23 Ocean Avenue plat

Ocean Ave No 23 Site Subdivision Plat 9 14 2016 Survey Review 9 23 2016.PDF

SITE/SUBDIVISION PLAN (PRELIMINARY)
 OF: 23 OCEAN AVENUE
 PORTLAND, MAINE
 FOR RECORD OWNERS:
STEVEN E. AND ROBERTA S. COPE
 PORTLAND, MAINE 04104
 F.O. BOX 1396
 Four Points Associates, Inc.
 Donald E. Dostie PLS, Principal
 9 Ralph Avenue, Lewiston, ME 04240
 Tel. 207-577-5840

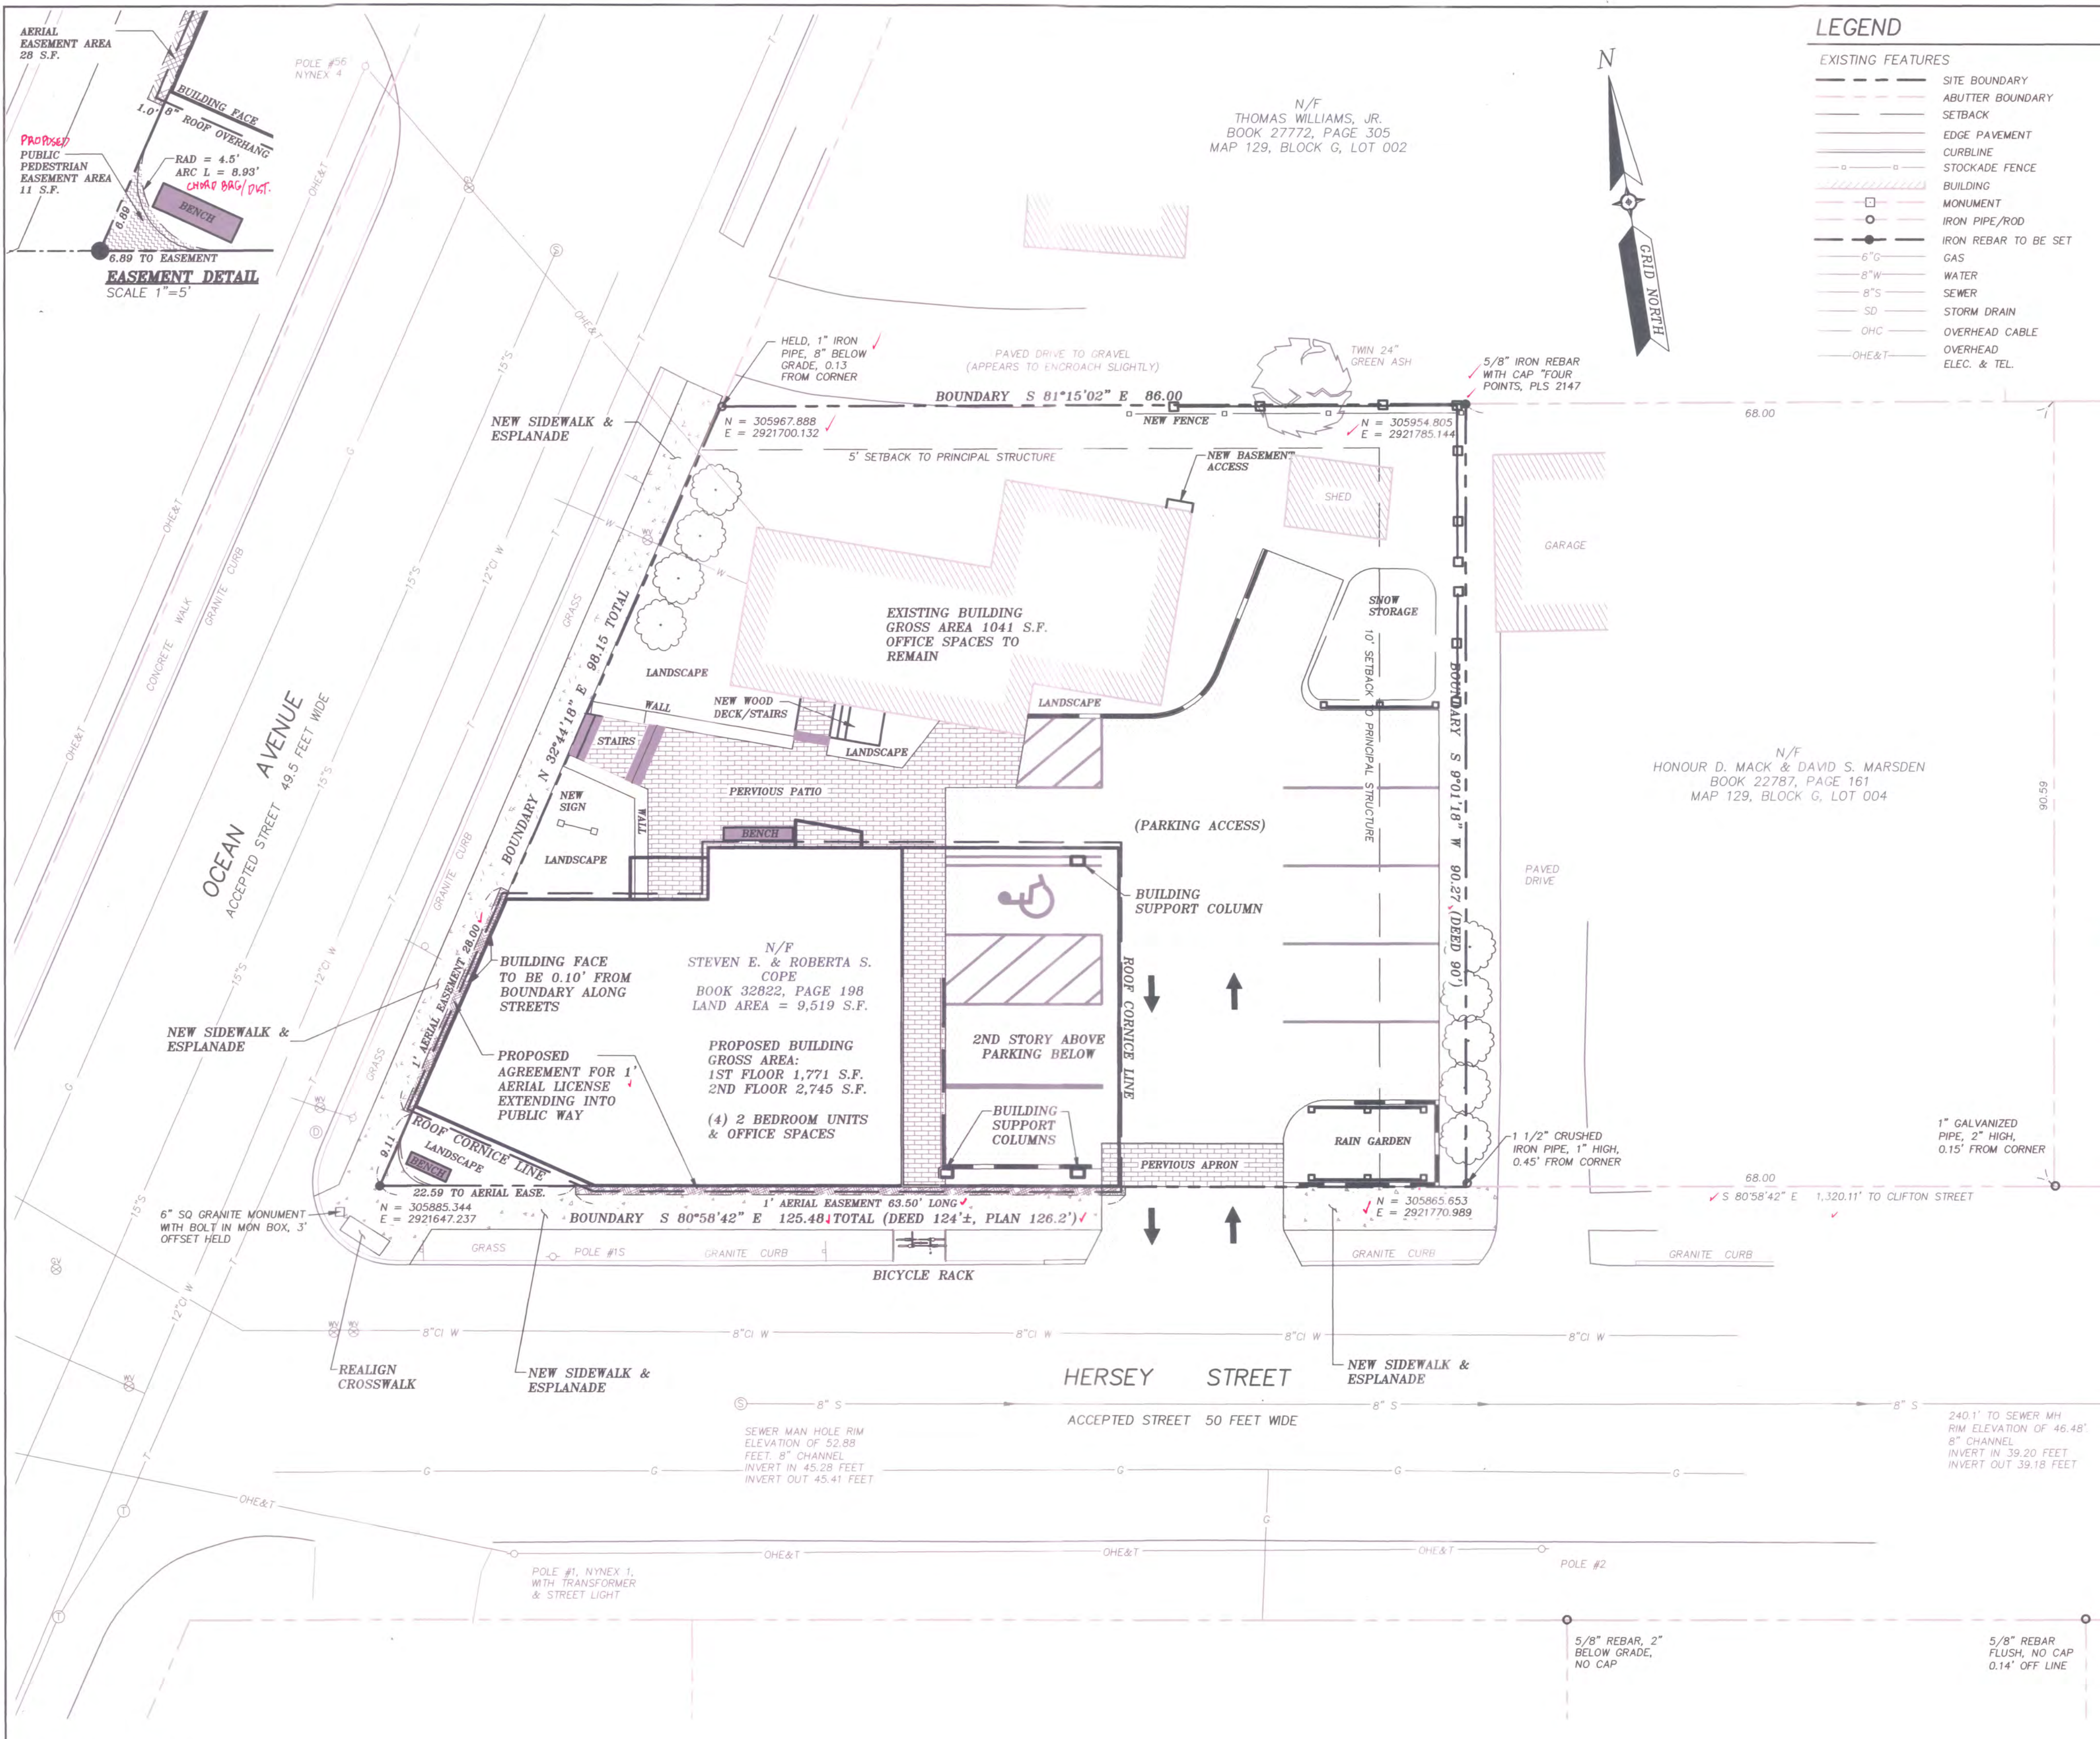
I would just ask for three minor items. Survey review plan markup attached.

1. Add chord bearing and distance for the proposed pedestrian easement detail.
2. Add text "Proposed" before "Pedestrian Easement".
3. Possibly add height clearance for the one foot wide aerial easements along Ocean Ave and Hersey St.
